UNITED STATES PATENT AND TRADEMARK OFFICE

Office Action Summary	Application No. 10/571,215	Applicant(s) DEICHMANN ET AL.	
	Examiner JESSICA L. MYERS	Art Unit 3746

DETAILED ACTION

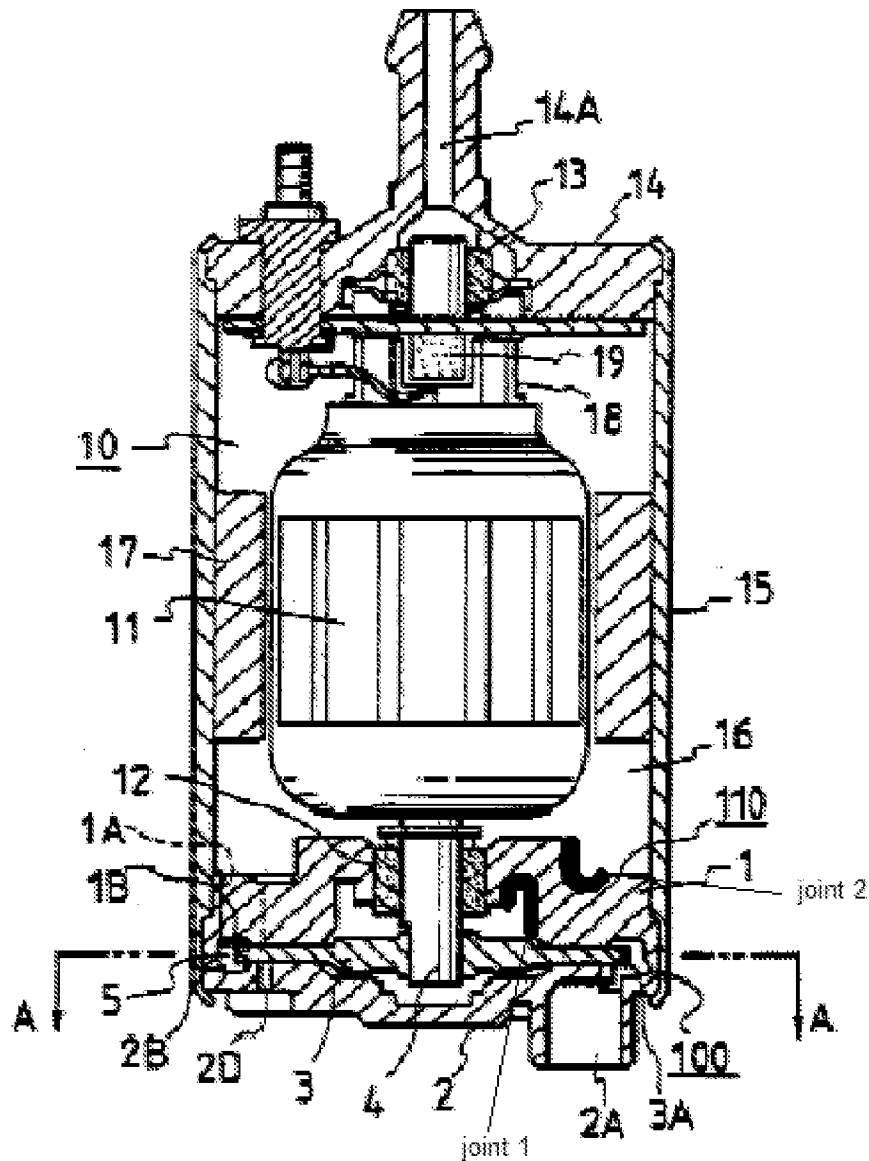
Kemmner et al. teach a fuel feed unit for a motor vehicle (see abstract) having a fuel pump (fuel feed unit (12)) which is driven by an electric motor (electric motor (20)), and having a rotor (impeller (34)) of the fuel pump arranged between two housing parts (dividing wall (28) and cover (38)), the rotor being fastened in a rotationally fixed manner to a shaft of the electric motor (see figure 2 with shaft (24)), characterized in that at least one of the housing parts has an expansion joint (The dividing wall (28) has an axial bearing portion that abuts the shaft (24) and a radial portion that encloses the impeller. There are two joints between the axial and radial portions that would allow the assembly to expand and contract as the temperature in the pump unit increases and decreases, see the figure below).

Kemmner et al. teach the fuel feed unit as claimed in claim 1 (see the rejection of claim 1 above), characterized in that the housing part which faces toward the electric motor has a radial section which runs toward the shaft (the portion of the wall (28) which directly abuts the shaft and acts as a bearing for the shaft) and an axial section which leads away from the rotor parallel to the shaft (the portion of the dividing wall (28) that encloses the impeller).

Kemmner et al. teach the fuel feed unit as defined in claim 3 (see the rejection of claim 3 above), wherein the expansion joint on the axial section runs over the entire height of the radial section (the height of joint 1, as shown in the above figure, is approximately the height of the dividing wall (28)).

Kemmner et al. teach the fuel feed unit as defined in claim 3 (see the rejection of claim 3 above), wherein the expansion joint is arranged in the corner region at which the two sections adjoin one another (both joint 1 and joint 2, as shown in the above figure, are located at a corner formed between the axial section and the radial section of the wall).

Kemmner et al. teach the fuel feed unit as defined in claim 3 (see the rejection of claim 3 above), wherein the expansion joint is arranged on the side of the housing part facing toward the electric motor which faces away from the rotor (joint 2, as defined in the above figure, is arranged on the side of the wall that faces the pump motor).

Kemmner et al. teach the fuel feed unit as defined in claim 3 (see the rejection of claim 3 above), wherein the axial section and the radial section are produced in one piece (both the axial section and the radial section are formed from the dividing wall (28)).

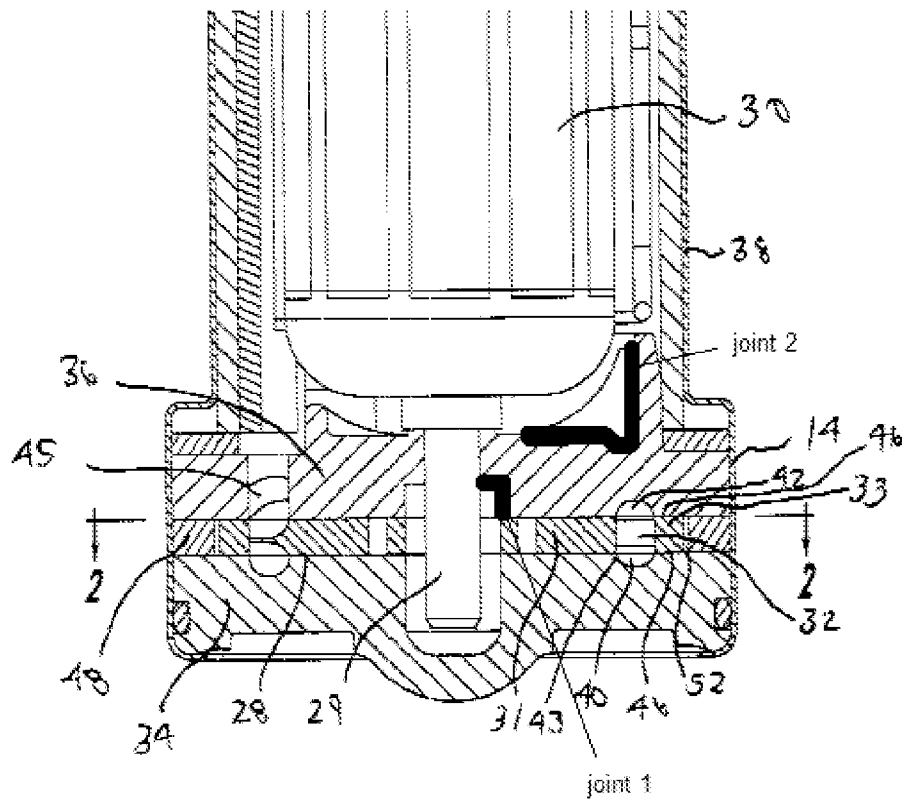
(10)), and having a rotor (impeller (3)) of the fuel pump arranged between two housing parts (pump base (1) and pump cover (2)), the rotor being fastened in a rotationally fixed manner to a shaft (shaft (4)) of the electric motor, characterized in that at least one of the housing parts has an expansion joint (The pump base (1) has an axial bearing portion that abuts the shaft (4) and a radial portion that encloses the impeller. There are two joints between the axial and radial portions that would allow the assembly to expand and contract as the temperature in the pump unit increases and decreases, see the figure below).

Iwai et al. teach the fuel feed unit as defined in claim 3 (see the rejection of claim 3 above), wherein the expansion joint is arranged on the axial section near the rotor and is embodied as a spacing of the housing part from the shaft (Joint 1, as defined in the above figure, is formed as a cut out in the axial section of the base (1), in such a way that the base is spaced from the shaft).

Iwai et al. teach the fuel feed unit as defined in claim 3 (see the rejection of claim 3 above), wherein the expansion joint runs over approximately half of the axial section (Joint 1, as defined in the above figure, is approximately half the height of the base (1)).

Iwai et al. teach the fuel feed unit as defined in claim 3 (see the rejection of claim 9 above), wherein the expansion joint is embodied as a groove which runs all the way around the axial section (Joint 1, as defined in the above figure, is formed as a groove which surrounds the shaft and is located in the axial section of the base (1)).
